SECTION 00911 - ADDENDUM 5

- A. Project Name: South Main Corridor Improvement Project
- B. Engineer: SK Design Group, Inc.
- C. Engineer's Project Number: 16-108.
- D. Date of Addendum: March 11, 2021

C00.52

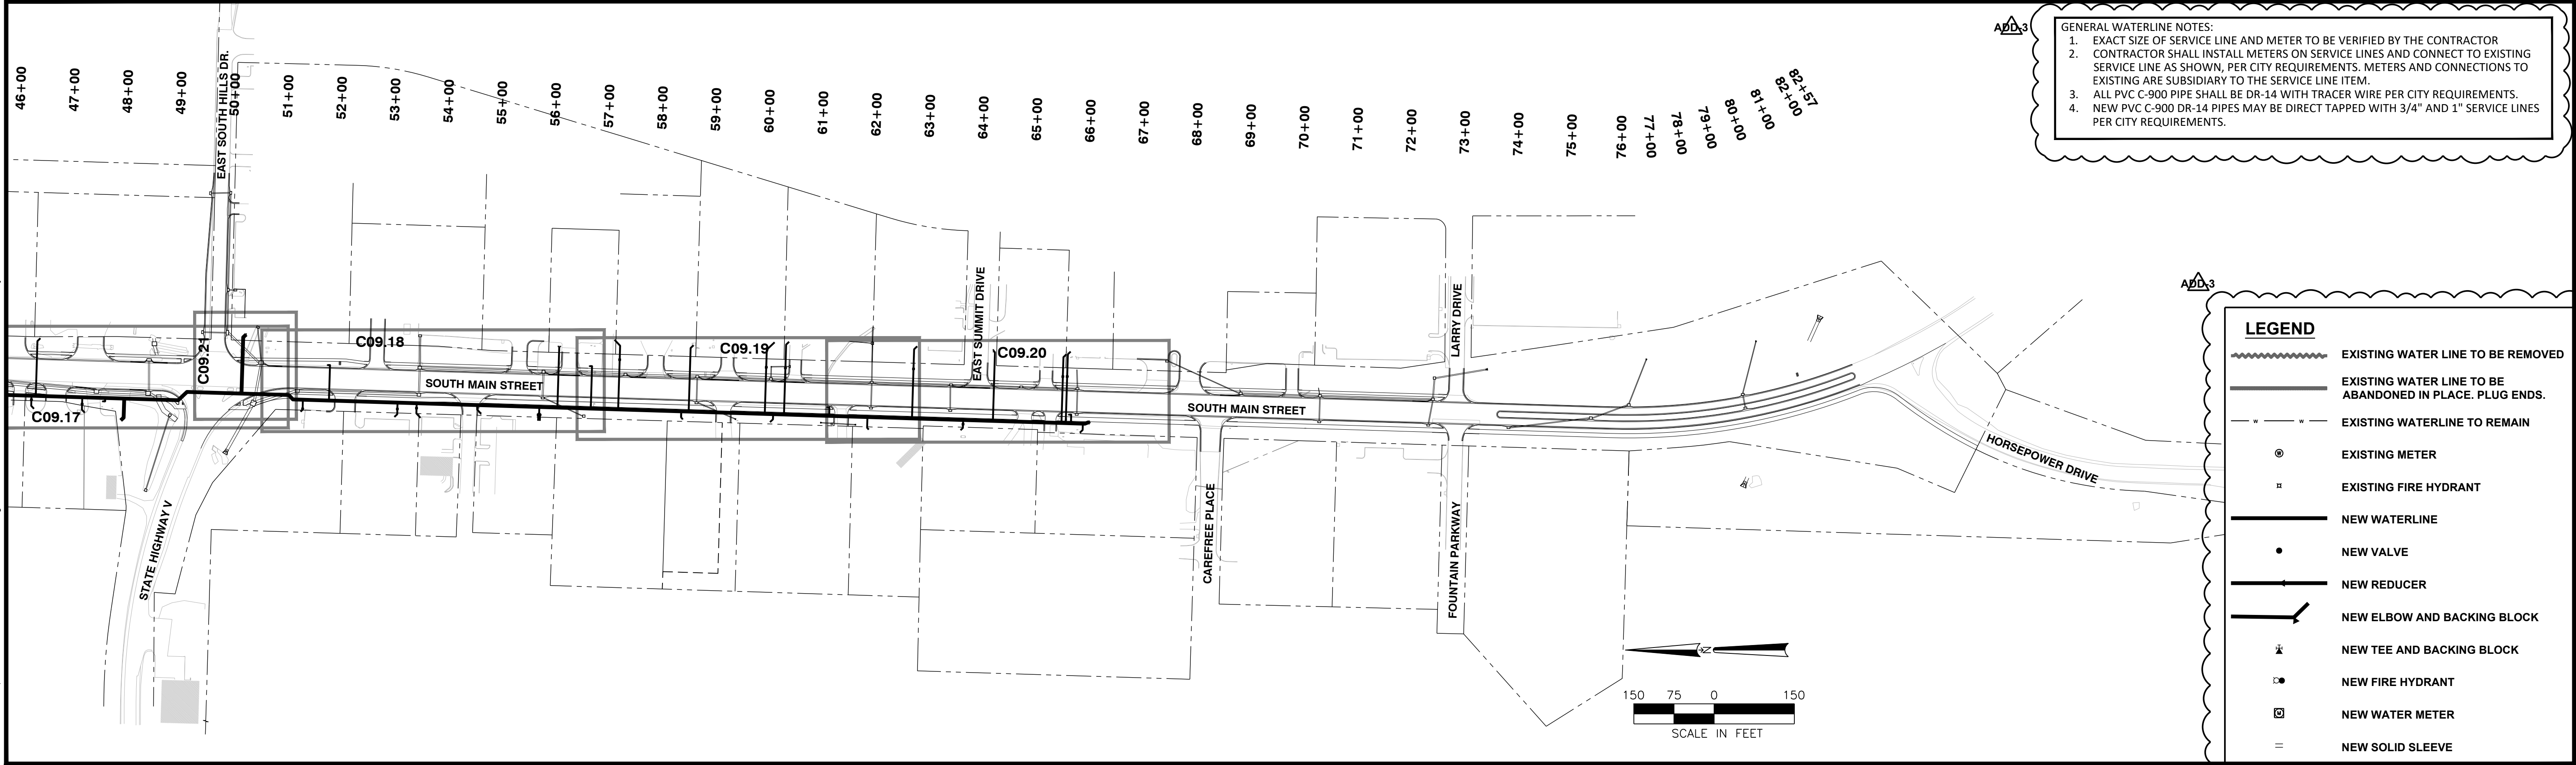
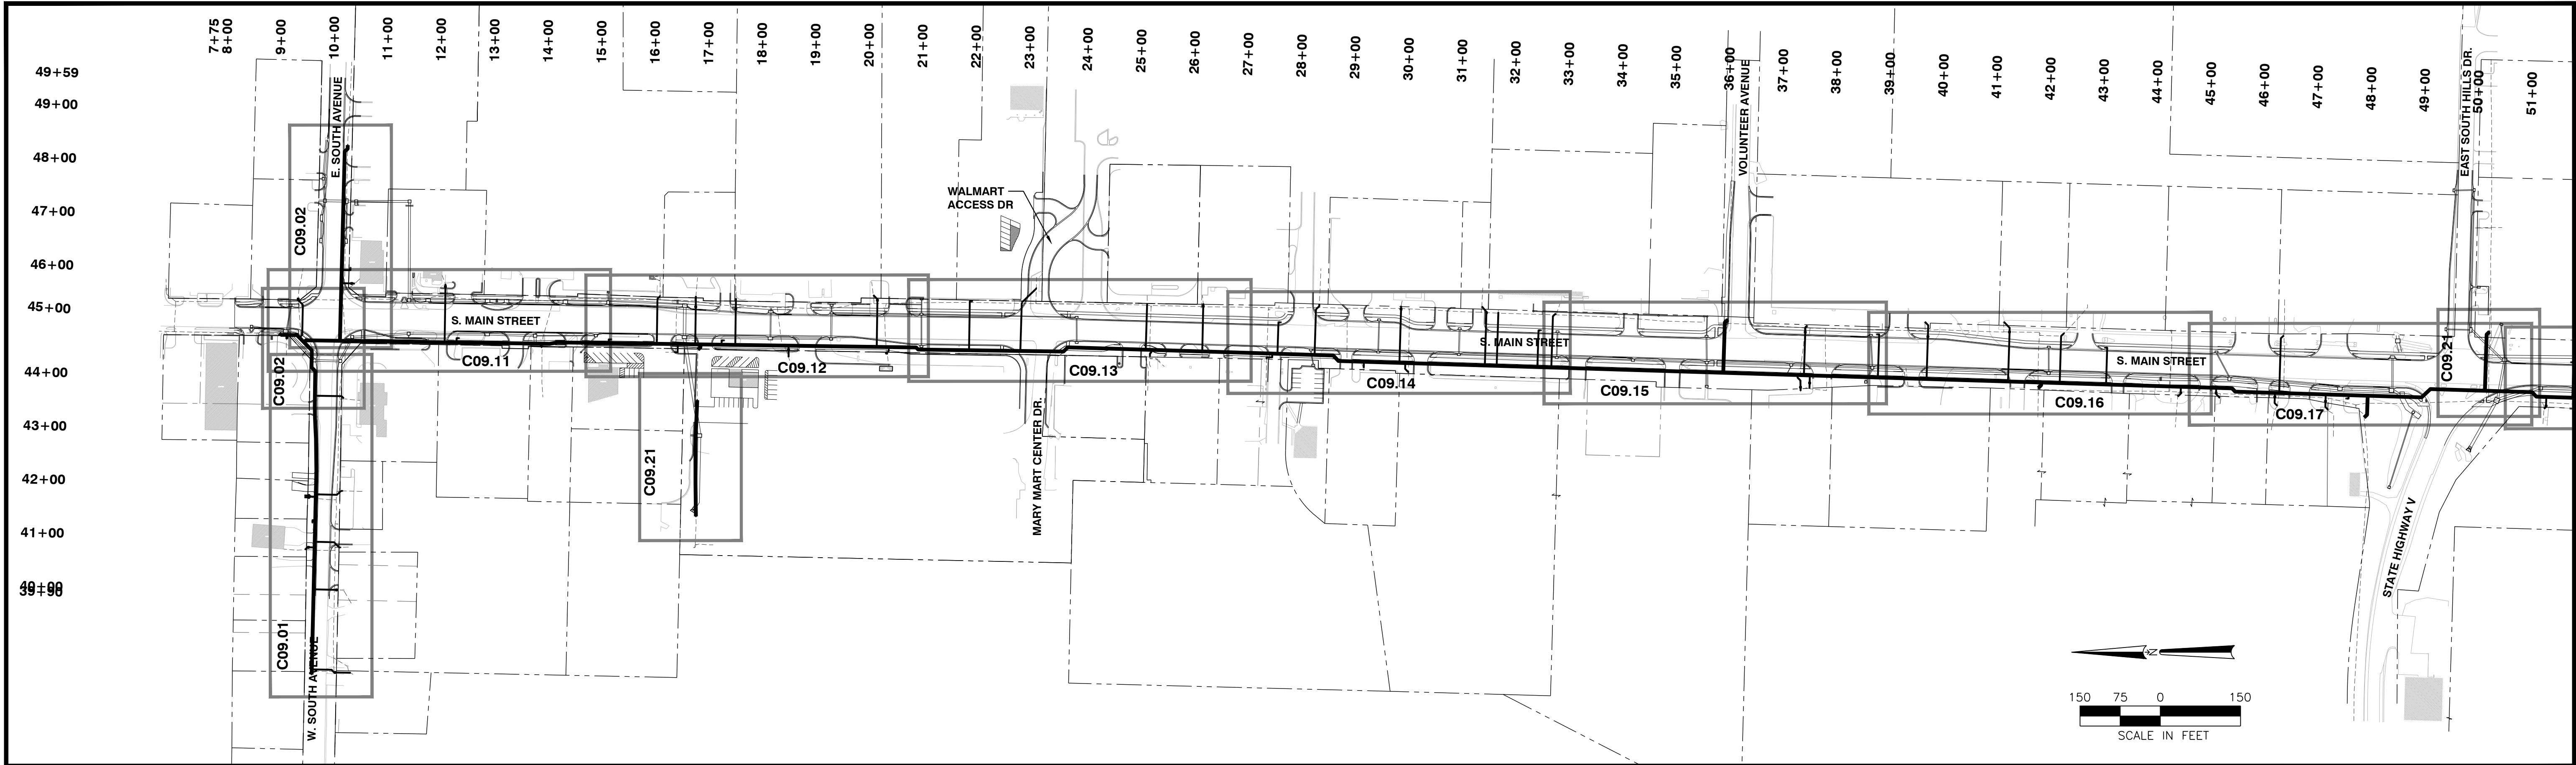
- A. Delete the following drawing sheets in their entirety and replace with attached revised and clouded drawings dated 03/xx/2021.
 - 1. Sheet C00.52 – Revised quantities and deleted item number 73
 - 2. Sheet C09.00 – Reflects revisions to waterlines
 - 3. Sheets C09.01, C09.02, C09.11 to C09.21 – added service line lengths and fittings
 - 4. Sheet C09.51 – Deleted conversions and revised notes
 - 5. Sheet C10.01 – Deleted microfiber.
